**CALIFORNIA COASTAL COMMISSION**

**STAFF REPORT: APPEAL  
 DE NOVO COASTAL PERMIT**

APPEAL NO.: A-3-SCO-98-101

PROJECT DESCRIPTION: Reconstruct a 13,127 sq. ft. building and add 9,796 sq. ft. for a three-phased, mixed use project (commercial/residential/manufacturing); grade for and construct a new parking area (see Exhibit 3)

WEST ELEVATION

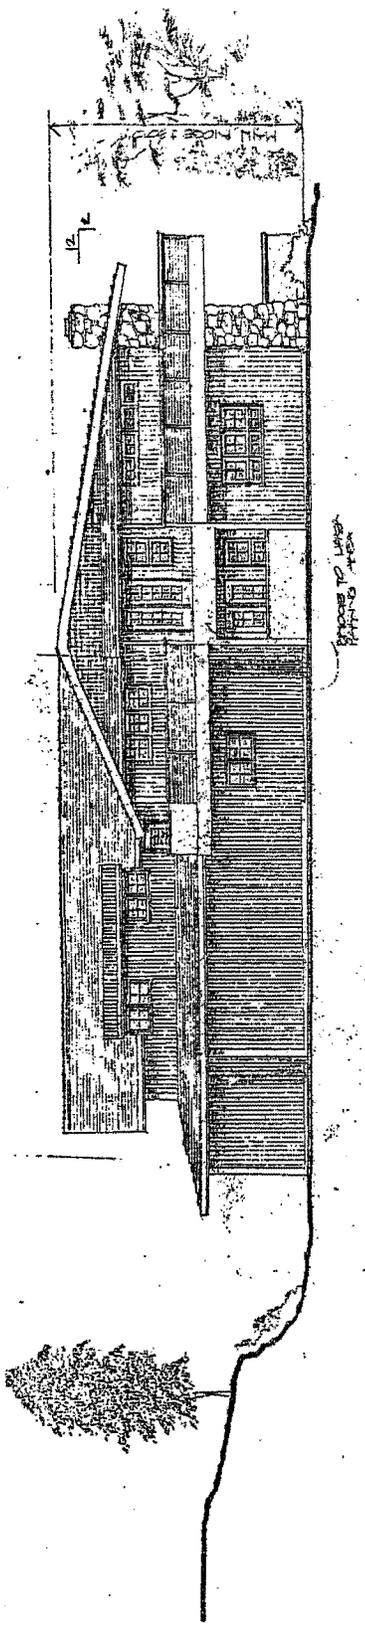
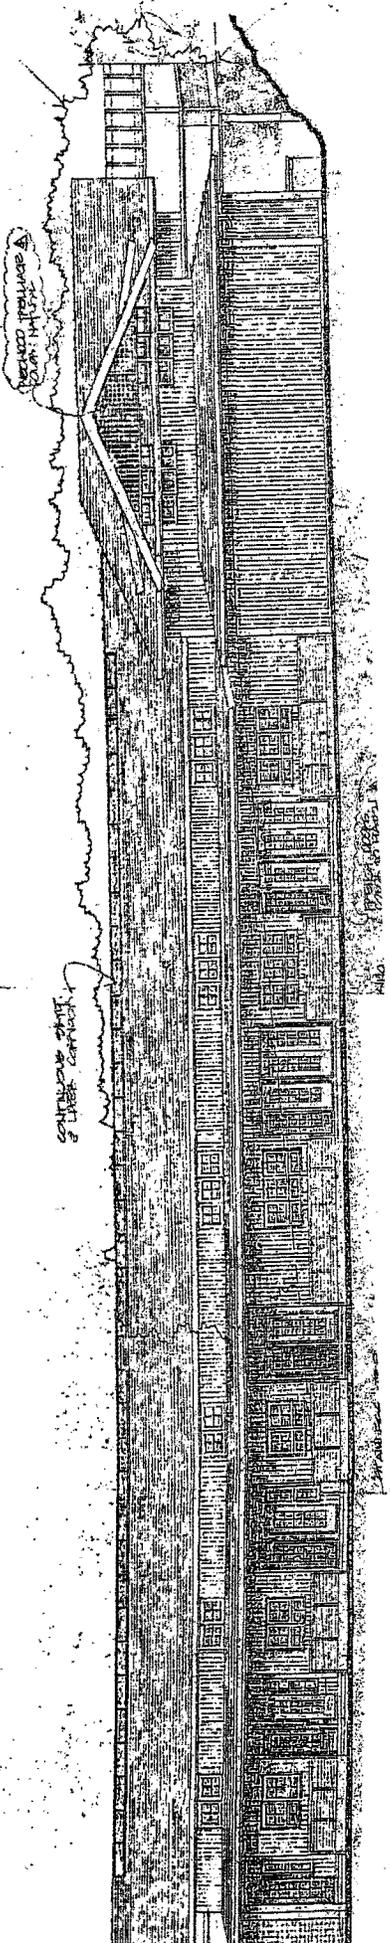
Nonetheless, in order to accommodate the new uses, certain exterior architectural modifications are proposed. The County-approved plans show that these modifications include increasing the roof height at the north end of the structure by three to six feet, resulting in a somewhat bulkier appearance and an increased "skyprint" (i.e., profile against the sky). Also, the footprint of the existing structure would be increased by 234 sq. ft. Thus the effort to accommodate the new and increased level of uses results in a somewhat larger building profile, which in turn increases the amount of development between Highway 1 and the scenic shoreline of the Santa Cruz County coast. Additionally, the higher profile would result in a slight increase in the amount of development visible from the beach.

1. All structural improvements shall be made within the existing footprint and profile of the main building, except for decks and outbuildings. The footprint shall be reduced to conform to the plans in Exhibit 2 and the Variance approval, removing the portion in the Caltrans right-of-way to a setback of four feet at ground floor level. The profile of the main building is established by the existing elevation of the highest point of the roof above sea level.

REVISIONS TO PLANS

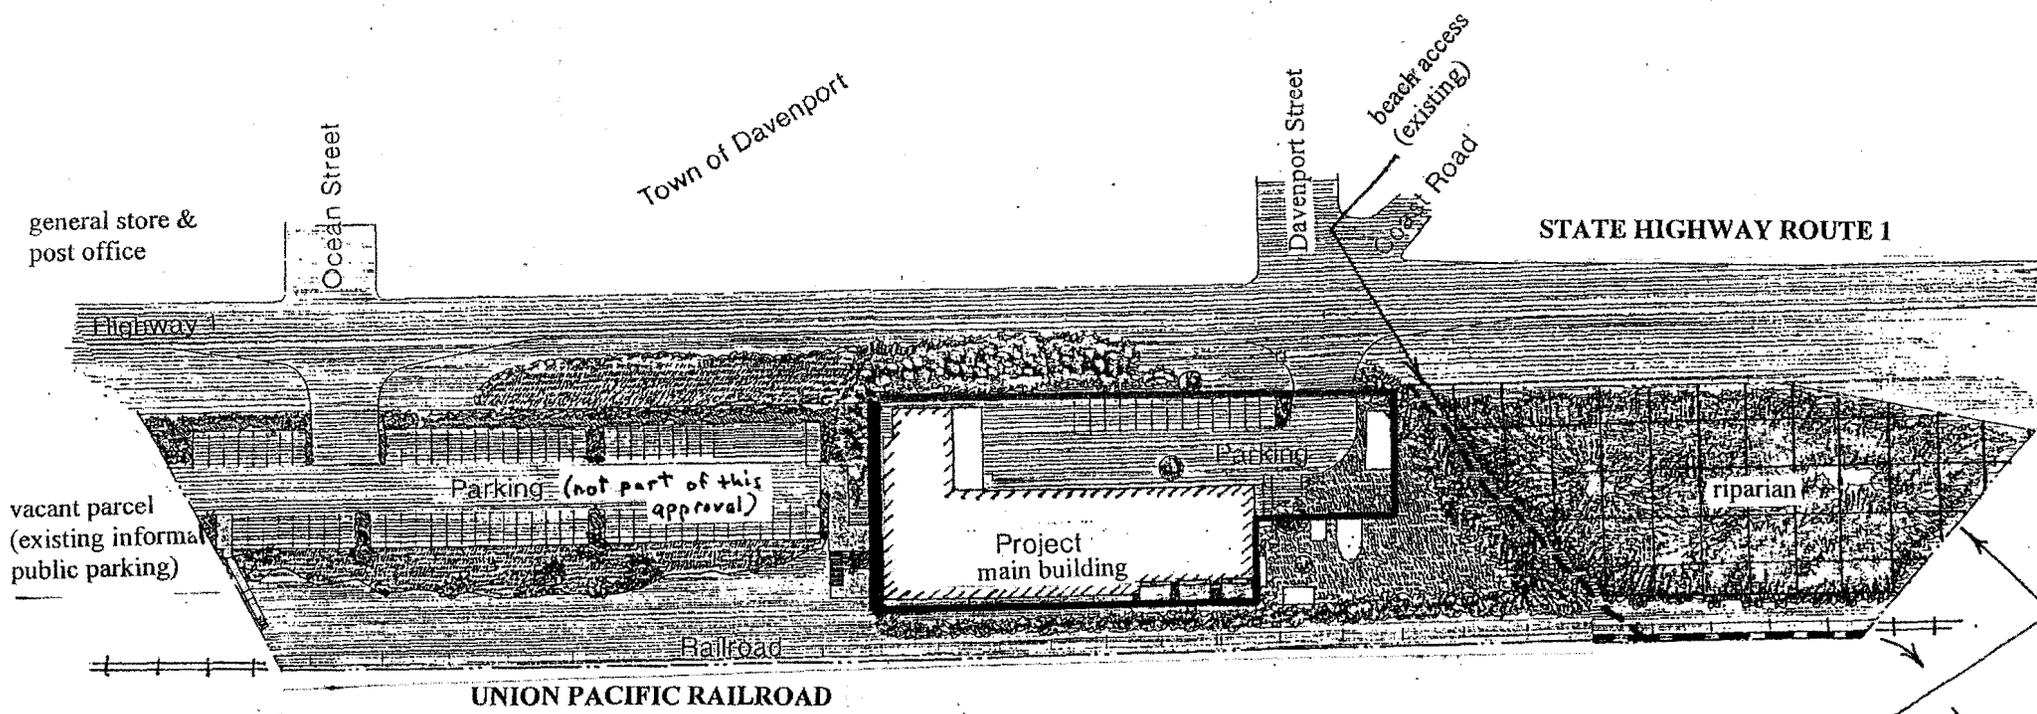
THE FOLLOWING NEED TO BE INCORPORATED INTO ALL RELEVANT  
SHEETS OF THE FINAL PLANS

**NOTE:** The limits of this open space area may be more precisely delineated by a qualified biologist, but in no case shall it restrict the use of the existing beach access trail.
